Phase One of the Upper Brook Street Masterplan

Response to Comments from Manchester City Council Highway Officers and Active Travel England on Planning Application

14 November 2023 version 1.0

Figure 7 taken from Transport Assessment – showing bollard location

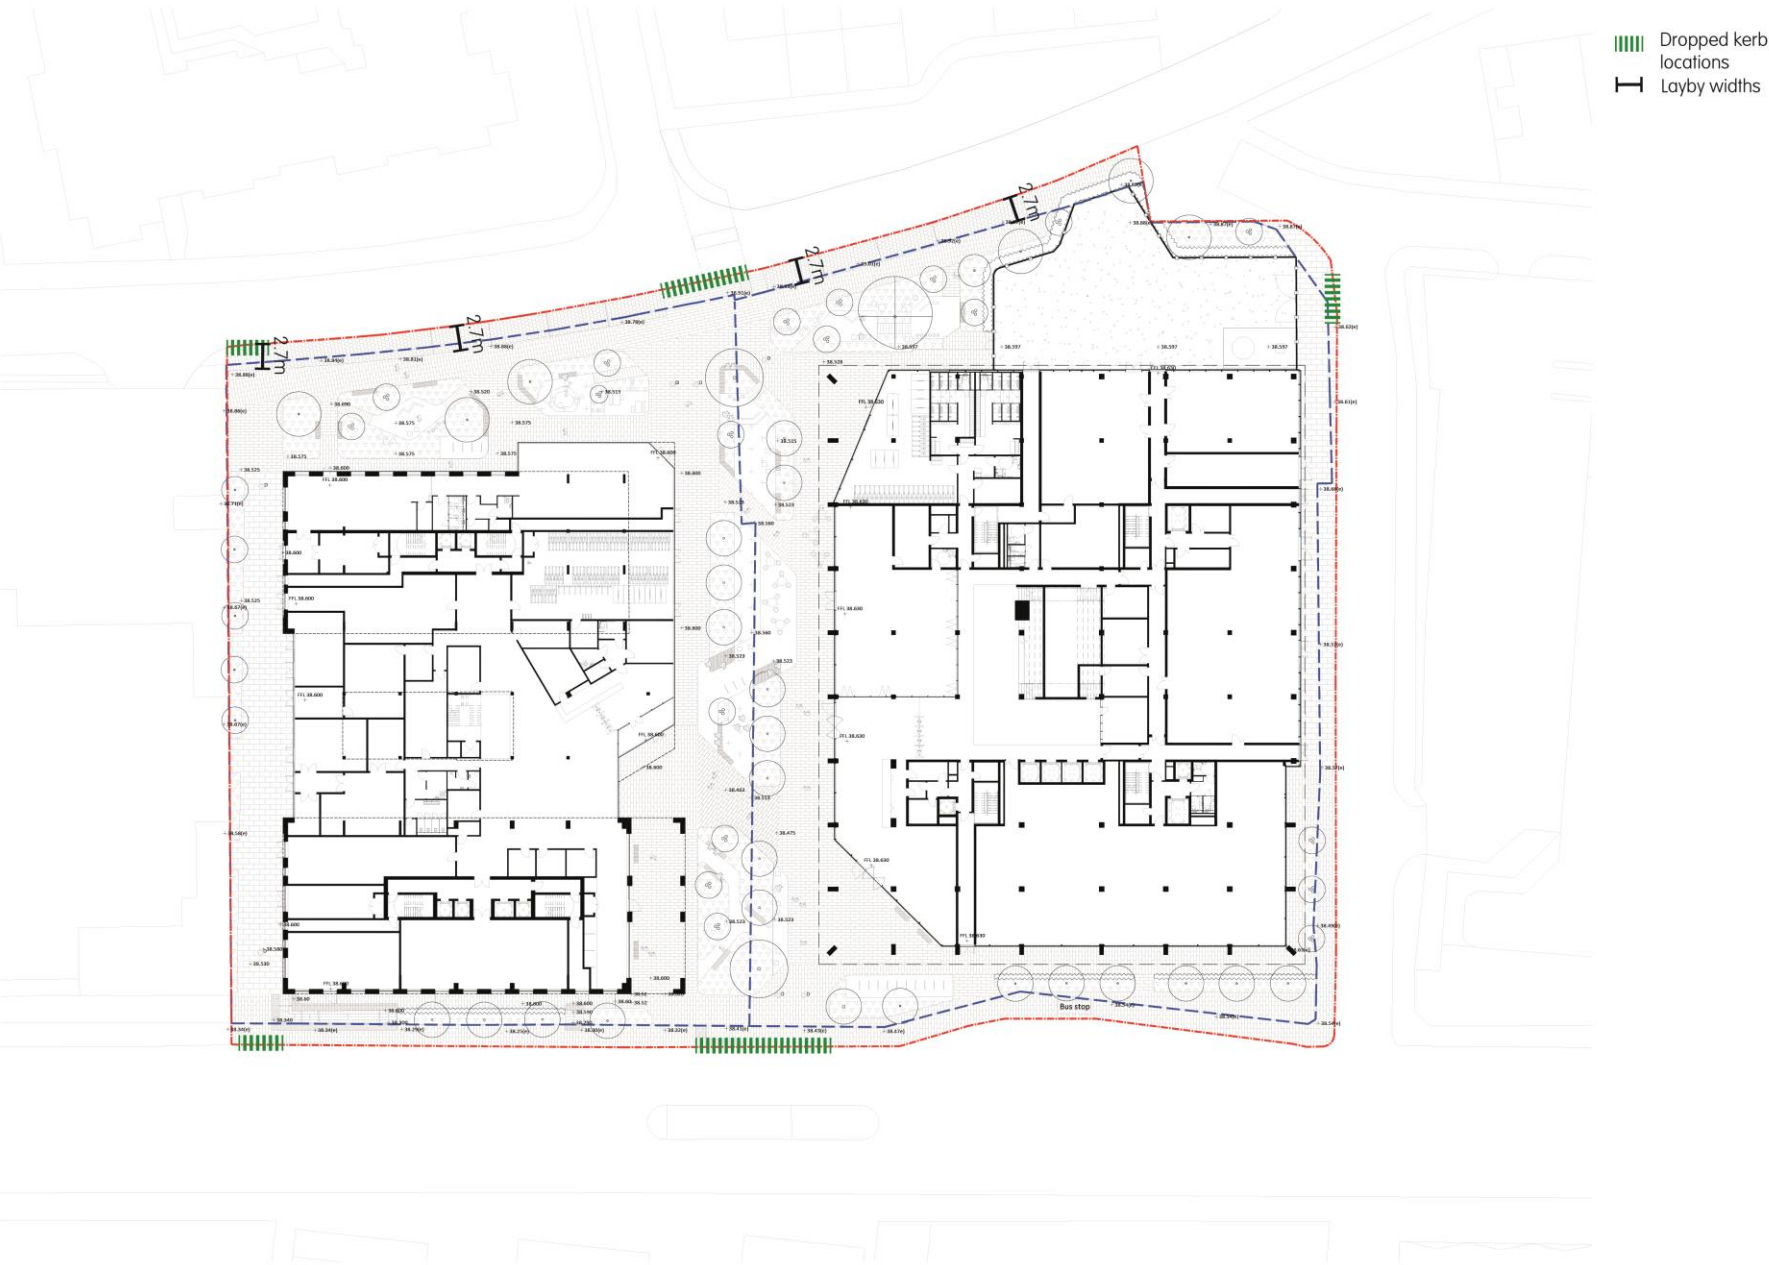
Highways also note sections of unadopted hardstanding are proposed adjacent to the North West Road access and Thorburn Walk access points at both Upper Brook Street and Kincardine Road which may attract car parking. Highways therefore suggest that moveable restrictions are implemented at these locations in order to physically prohibit parking at these locations.	Section 4.7 of the Transport Assessment states: "bollards or other movable obstructions will be provided at the access to Thorburn Walk from Kincardine Road and Upper Brook Street to ensure that only emergency and authorised vehicles are able to enter this space. These are shown on Figure 7 (appended to this response note)."
Other works along Kincardine Road include provision of on-street disabled parking and loading bays to the southern side of the carriageway which will retain the carriageway width along the existing one-way section of Kincardine Road and will provide min. 2m retained footway width. However, no details on the proposed loading bay dimensions have been provided and so clarification is sought.	The loading bay will be 2.7m wide. A plan showing dimensions is provided at the back of this note. Tracking was provided on drawing 2584-CIV-XX-XX-S-H-40012 in the Transport Assessment and is re-provided here.

Mark-up showing dropped kerb locations and layby width

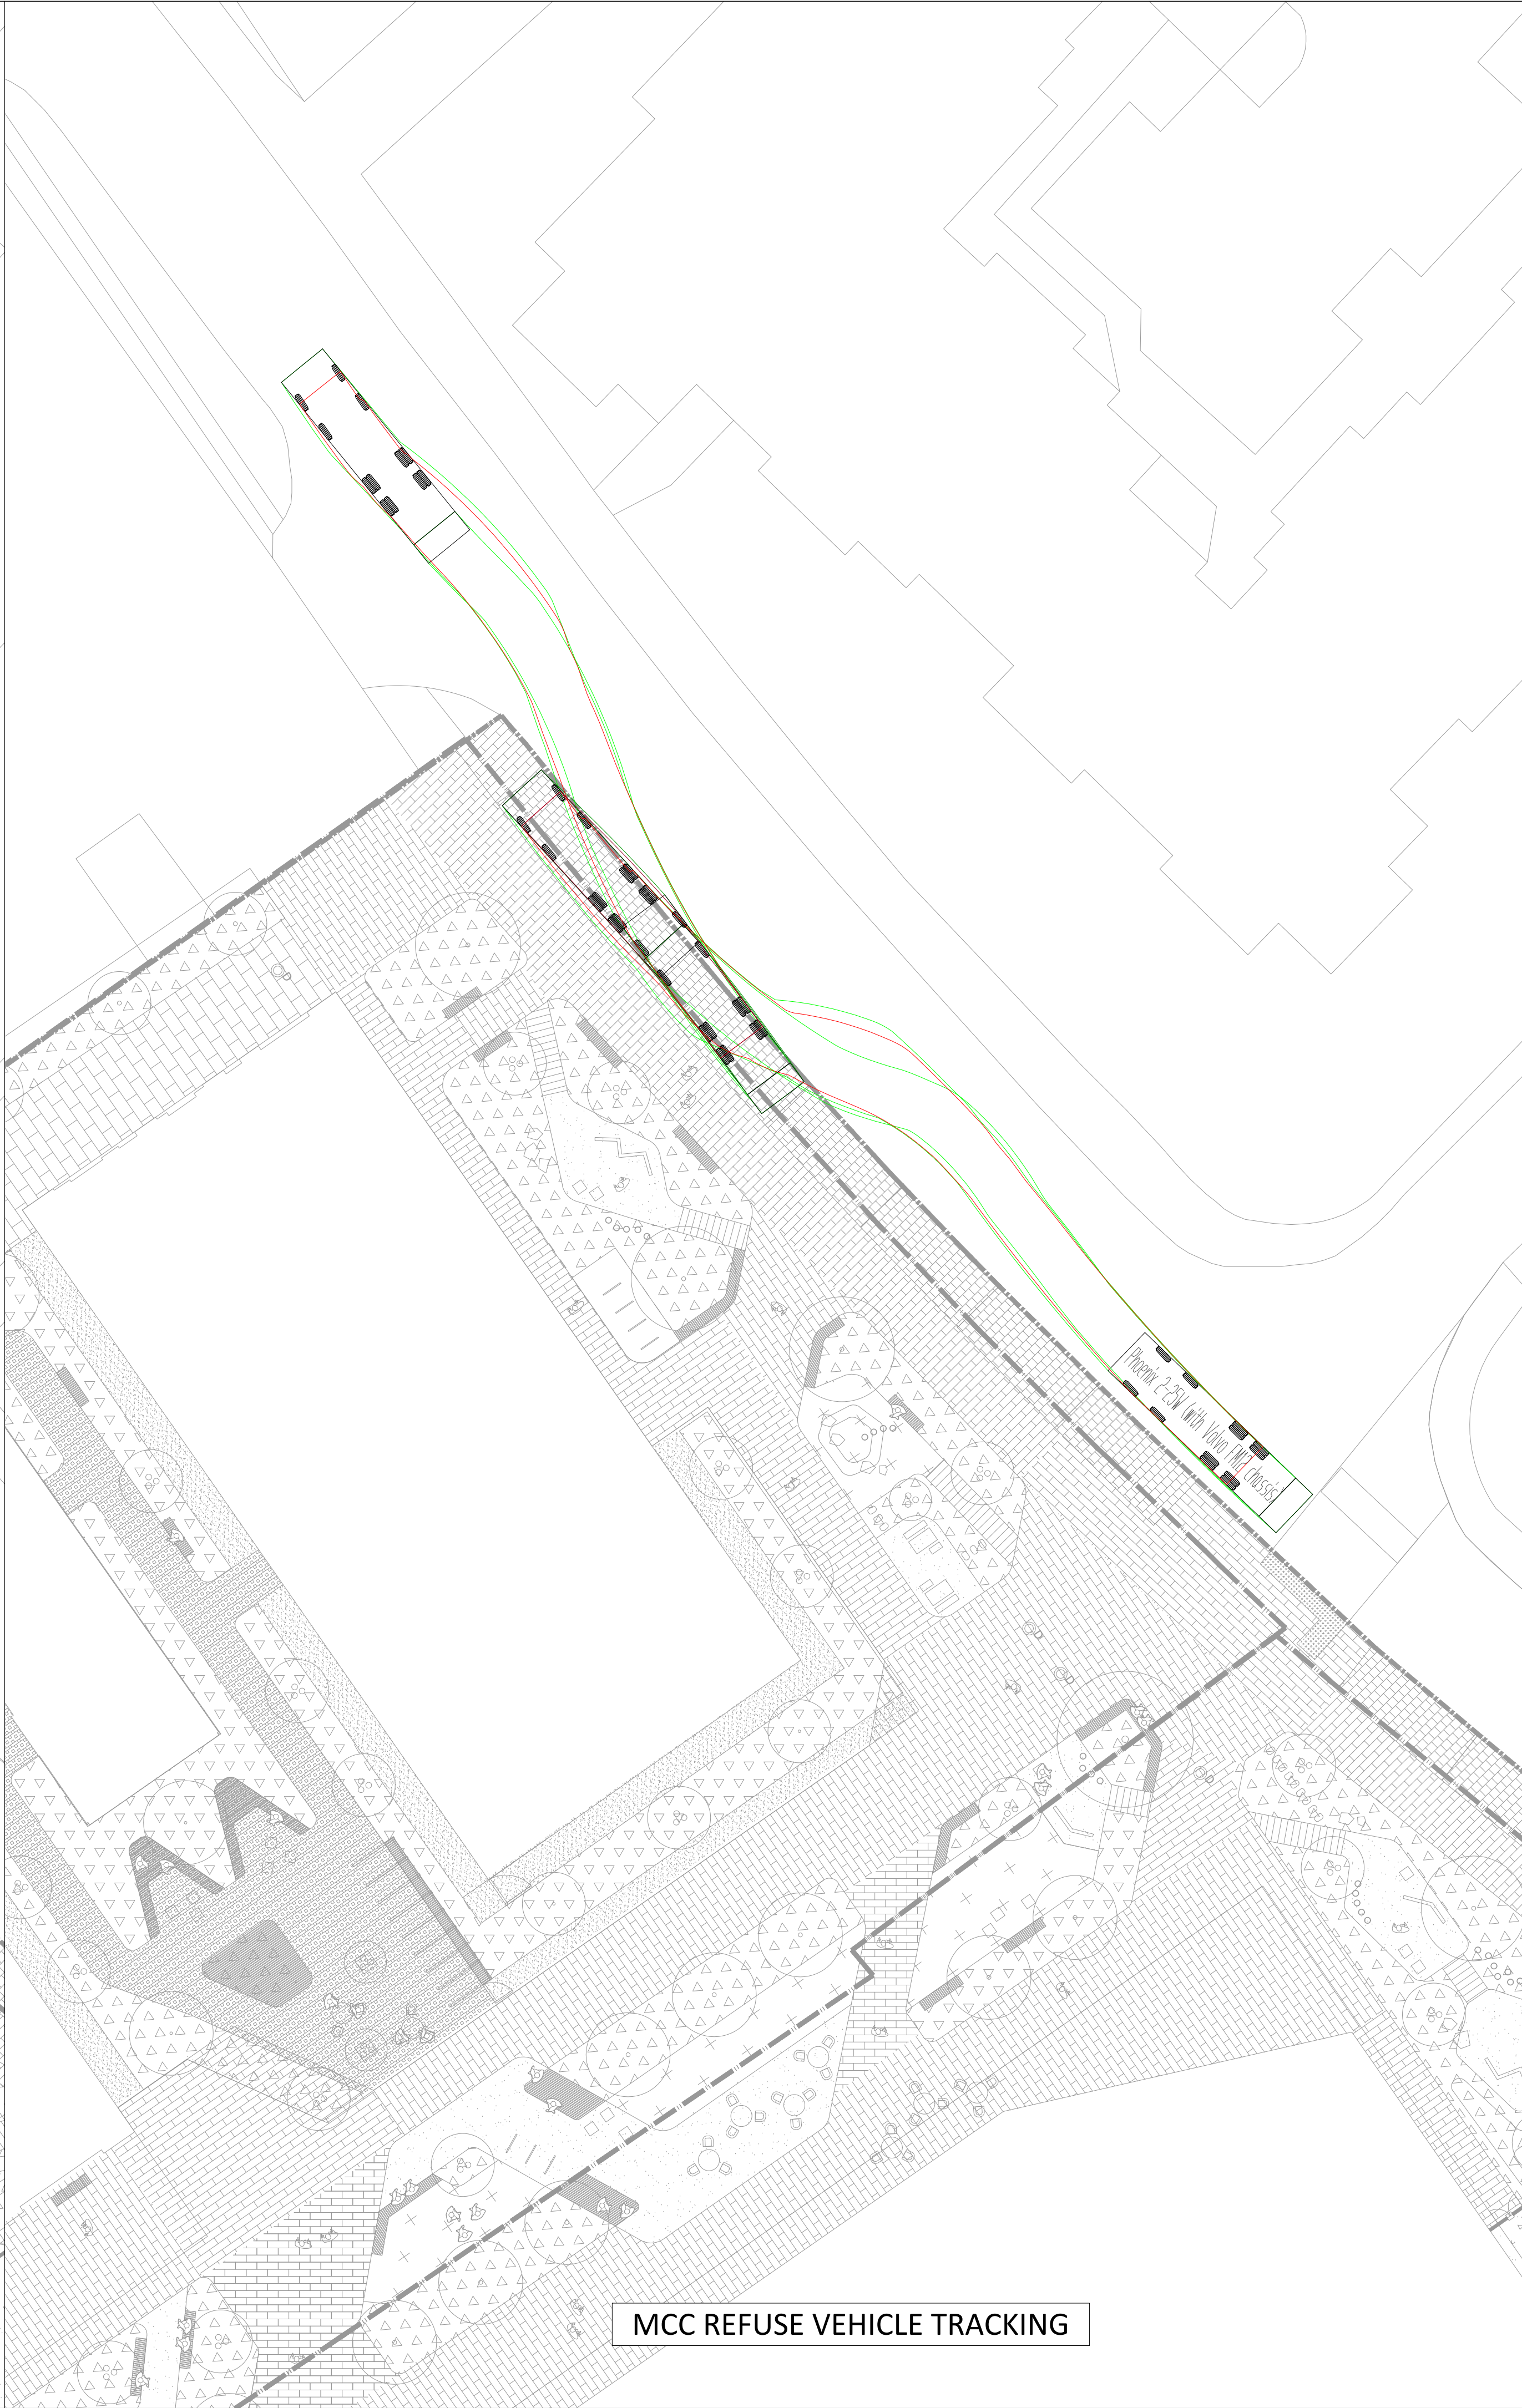
MCC Highway Officers Comments	Civic Engineers' Response:
former site should be reinstated as continuous footway to adoptable standards. - o Footway resurfacing and renewal undertaken as appropriate. - o Ensure the provision of tactile paving and dropped kerbs across nearby junctions serving the site. - o Ensure the provision of minimum 2-metre-wide footways throughout and surrounding the development.	Covered later in this list Covered later in this list Footways are a minimum of 2m at all points.
Refreshment of the TRO lining along Cottenham Street in order to enforce appropriate parking practices in this area should be agreed as part of the permission.	Agreed
The level of existing on-street pay-and-display provision along Kincardine Road would be retained as part of the proposals for the site and the adjacent application site (Ref.137401/FO/2023).	This application will not remove any of the existing parking on Kincardine Road.

MCC Highway Officers Comments	Civic Engineers' Response:
a S278 agreement. The works will also include resurfacing of Upper Brook Street and Kincardine Road footways, with pedestrian circulation around the Upper Brook Street (southbound) bus stop improved with the removal/relocation of the surrounding 4G masts.	
Emergency vehicle access will be provided along North West Road and Thorburn Walk via Upper Brook Street with egress onto Kincardine Road where dropped-kerbs will be required to facilitate such movements. Additional emergency access will also be provided via the Sci-tech service yard. However, the location of the dropped-kerbs is not clear. Further detail is required which demonstrates that access/egress could be facilitated along with the adjacent on-street parking and pedestrian crossing facilities.	See attached mark-up of the landscape plan which indicates dropped kerbs with green dashed lines.

VEHICLE TRACKING
MCC REFUSE/ LARGE RIGID (10m)
VEHICLE TRACKING TO PROPOSED
LOADING BAY ON KINCARDINE ROAD

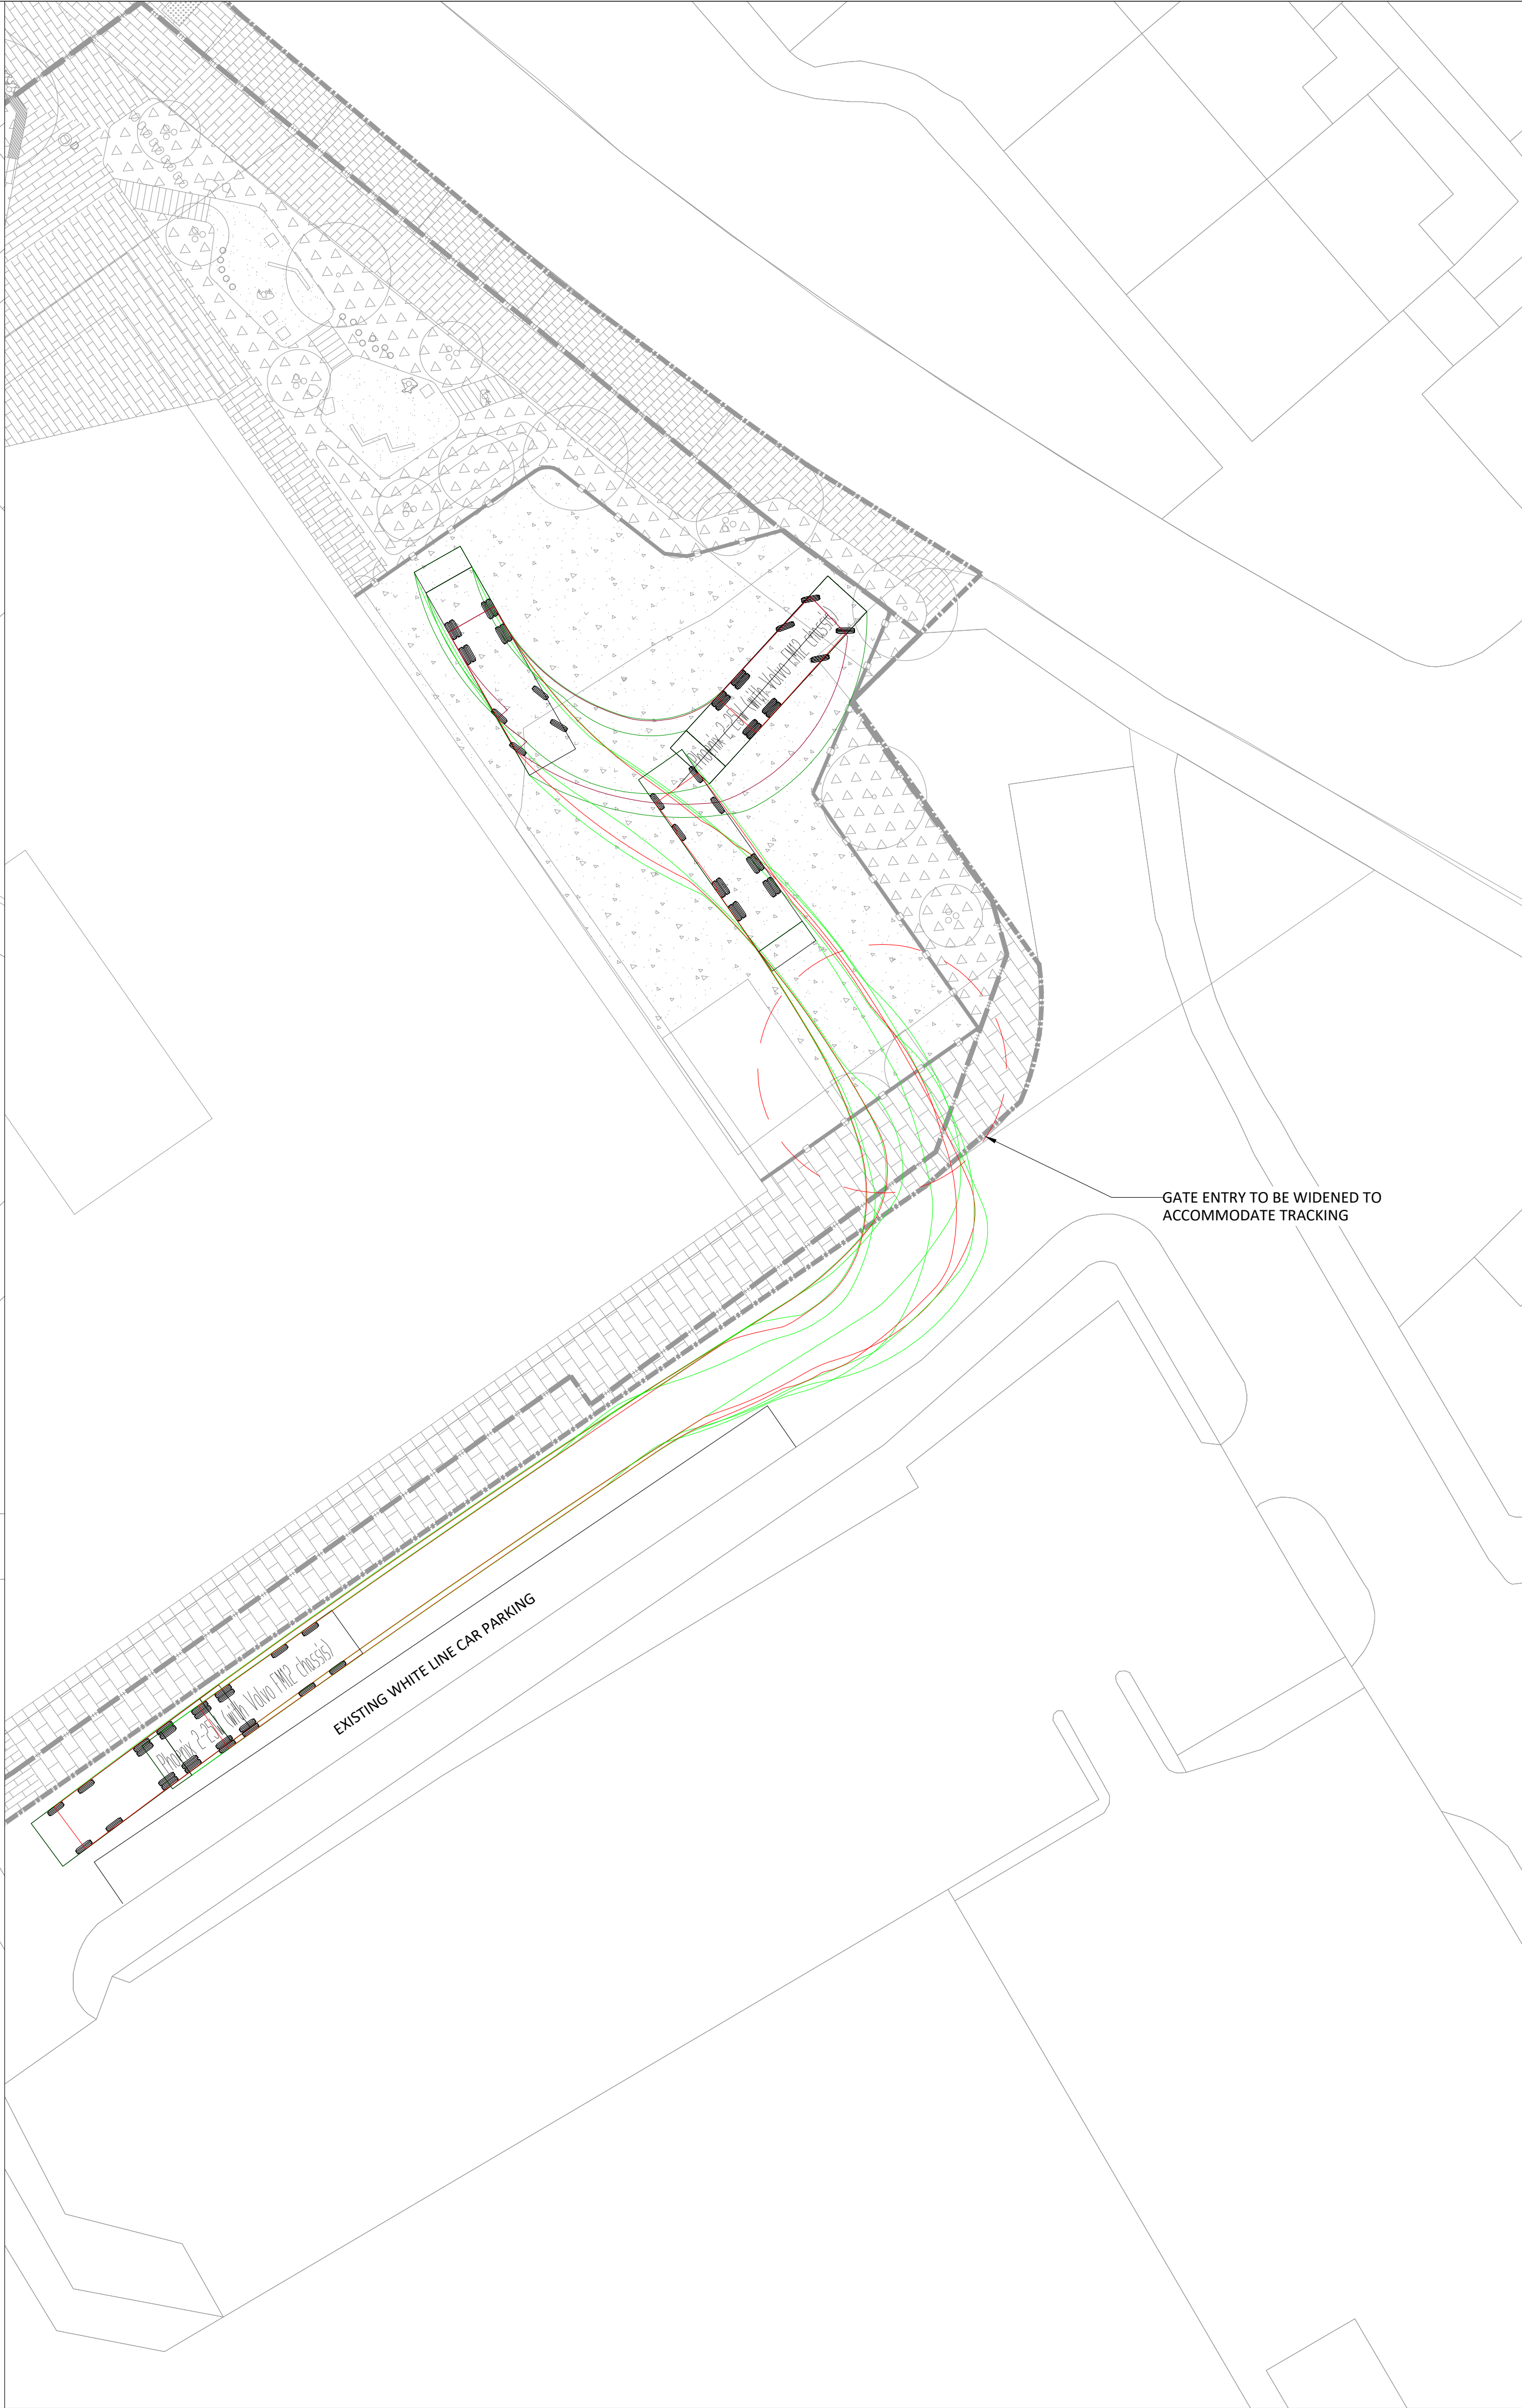
A new (full) loading bay is proposed on Kincardine Road to cater for refuse collections and deliveries associated with the student accommodation. Bins will be transferred from the PBSA building along via North West Road for servicing. Highways request that bins are stored in a holding area located within the site boundary prior to servicing and should not be placed onto the adopted footway for servicing.	See attached architects' plan from the Design and Access Statement which indicates where the holding area is to avoid bins blocking the footway on collection day.
Time-limiting traffic regulation order across the proposed	Tracking of Sci-tech service yard shows that all vehicles that need to serve the
